**RE: Submission of Part One of Two Responses to CEEA Round One
Information Requirements and Required Clarifications for the Nexen
Energy ULC Flemish Pass Exploration Drilling Project : CEAR 80117**

NEXEN ENERGY ULC FLEMISH PASS EXPLORATION DRILLING (2018 – 2028)

Environmental Impact Statement Addendum Responses to Round One Information Requirements and Required Clarifications – Part One of Two

Figure IR-06.1 Simple Depiction of Main Wellbore and Sidetrack Wellbore

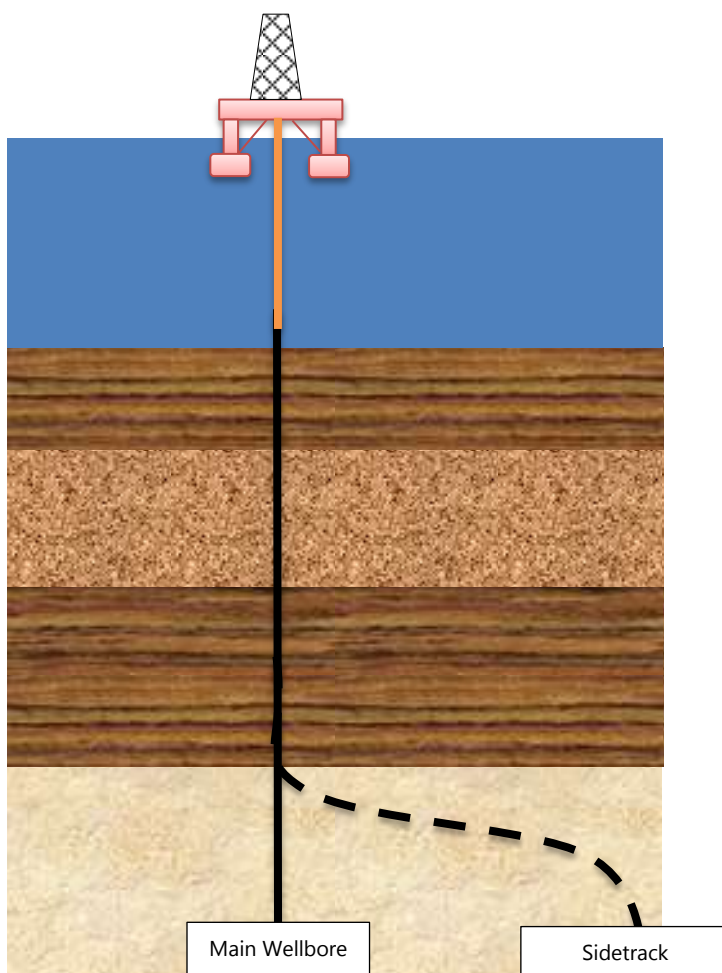
Specific Question or Information Requirement: Provide a description of project components and activities, including acid stimulation and sidetracking.

Sidetracking of the wellbore is an industry term for re-drilling a portion of the wellbore that has either been drilled to the planned total depth or partially drilled. This would involve permanently abandoning the section of wellbore below the start point from where the sidetrack well would be directionally drilled. Sidetracking might be done to either avoid an obstruction in the original wellbore or to reach another bottom hole location of geologic significance (i.e., geologic target). The impact on waste streams would be that a section of the wellbore would be drilled twice therefore generating additional drill cuttings that would be processed for discharge.

In the event of a sidetrack, the upper portions of the well would remain intact (i.e., no additional seabed penetrations, wellheads, or repositioning of the mobile offshore drilling unit (MODU)). Although sidetracking is currently not a planned activity, the additional time and associated waste streams have already been considered in the EIS (Section 2.9.2.3 and Appendix D).

The discussion above indicates that there are no plans to employ acid stimulation, and sidetracking is currently not a planned activity. However, both have been considered in the EIS, and the effects predictions presented in the EIS remain valid.

Figure IR-12.1 EIS Figure 5-42 Changes in Mean Monthly Water Temperature (1976-1995 to 1996-2015)

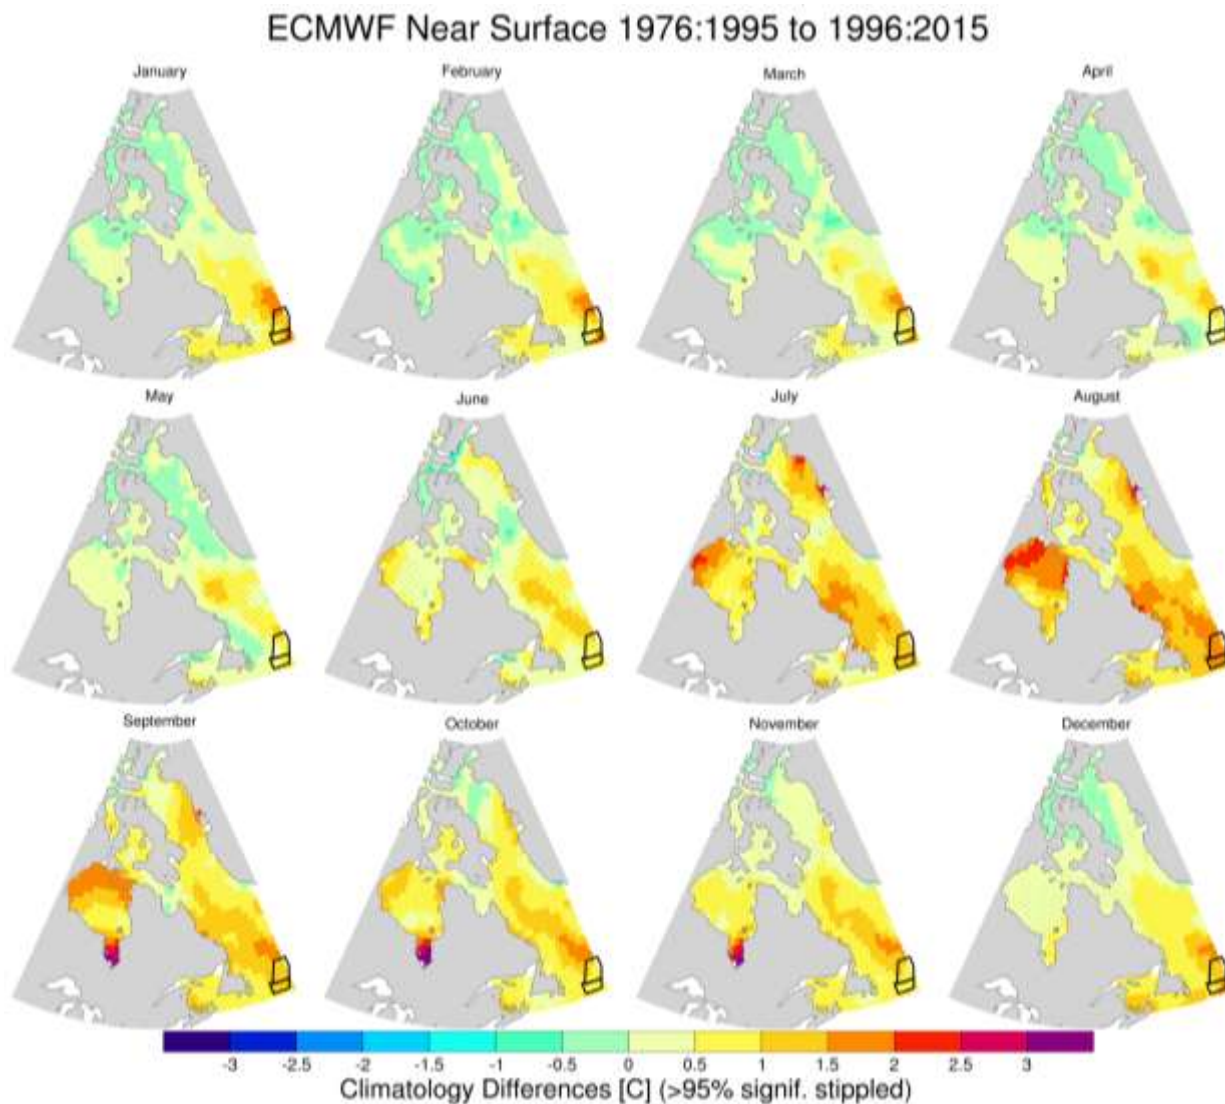
Part 3: Update the analysis of effects on Atlantic salmon, taking into consideration impacts that climate change may have had on the distribution of Atlantic salmon, and whether the Project could potentially contribute to or exacerbate an already declining population of salmon in the region.

As presented in Section 5.7.2.1 of the EIS, Figure 5-42 shows changes in mean monthly water temperature from 1976-1995 to 1996-2015 at depths of approximately five metres, based on European Centre for Medium-Range Weather Forecasts (ECMWF) reanalysis data. The Project Area has experienced warming in each month, although statistically significant warming is most prevalent from late summer to early winter. Warming was also found to be widespread at depths of approximately 45 m (not shown in Figure 5-42 of the EIS).

The limited interaction between salmon migrating within and near the Project Area and post-smolt and adults feeding north in the Labrador Sea and kelts along the southern edge of the Grand Bank will most likely remain low given the predicted increases in SSTs (i.e., lower suitability) near the Project Area. As the potential for environmental effects of planned Project activities and overall risk to Atlantic salmon is low, it is predicted that the Project will not contribute, nor exacerbate declines, to salmon populations.

The conclusion in the EIS, based on available data, remains valid: the Project is not likely to result in significant adverse environmental effects on marine fish and fish habitat, including Atlantic salmon.

Figure IR-22.1 Total Drill Cuttings Deposition, EL-1144 Deepwater Jurassic Example Well. Left) June, one Simulation (1 Jun); Right) "June", 46 Simulations (1 May-30Jul, every 2 days)

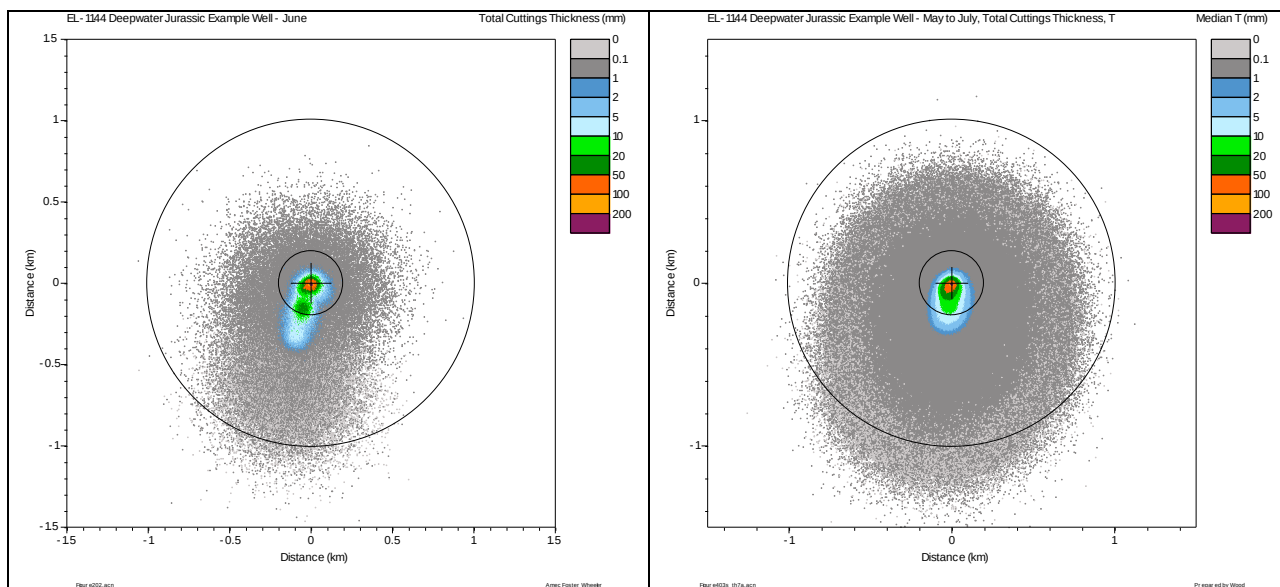
The EIS states, "It is assumed that the currents are representative of the two locations and are uniform over the deposition grids (domain) modelled." DFO stated that if uniform currents are used, then the model is not a real 3D model as stated in the introduction. Moreover, Figures 3-1 to 3-8 show that velocities are not uniform over the domain. This simplification/ shortcut is not acceptable, especially as the selected location for the currents are from the lowest advection velocities. These figures suggest that as the particles move away from the release site, they should be entrained by stronger velocities.

- a. Incorporate stochastic analysis in drill cutting dispersion scenarios, or provide a rationale for use of four simulations.
- b. Explain whether the dispersion model has considered processes at the benthic boundary layer (e.g. the presence of a mud plume/cloud near the bottom, and how this affects drill cutting dispersion predictions). If this is not addressed by the model, discuss the implications for model results.
- c. Provide a justification for the assumption that currents are uniform over the deposition grids modelled.
- d. Provide a rationale for the model selected and for the use of the turbulent diffusion term, and discuss the limitations of modelling without the use of advective-diffusive equations.

Part 2a - While stochastic analysis may help gain some statistical significance in the interpretation of output predictions, the four deterministic scenarios (at each location) completed do consider seasonal ocean current conditions which should provide a reasonable prediction of the possible direction and extent of the cuttings footprints which is the primary objective for the modelling. A comparison of an EL 1144 Deepwater Jurassic Example Well, June deterministic run commencing 1 June (Figure IR-22.1, left panel) with a stochastic simulation that considers 46 ensembles run every second day from 1 May to 30 July (i.e., 'covering' June) (Figure IR-22.1 right panel), is shown below. These are the total cuttings footprints. The stochastic run (Figure IR-22.1 right panel) footprint shows the median thickness. Both predictions show similar footprint extent and thickness.

Part 2b - The dispersion model does not consider processes at the benthic boundary layer. This could include resuspension of cuttings with the potential for sediment mobilization based on current speed, e.g., clays and fines, potentially mobilizing at lower current speeds, sands requiring higher speeds to move. Breakup of flocculates might be expected to reduce near-bottom concentrations, i.e., particles resuspend and are advected away by the ambient currents. Bioturbation is another process and difficult to quantify the intensity and rate of reworking that might take place at any of the locations. These post-depositional processes are difficult to model and data are scarce. The implications of not modelling these processes can result in over-prediction of benthic impacts (IOGP 2016) and so using the predicted no effect threshold (PNET) values as a guide to areas potentially affected is likely conservative. Conservative in the sense that subsequent resuspension and further transport would likely make the thicknesses smaller.
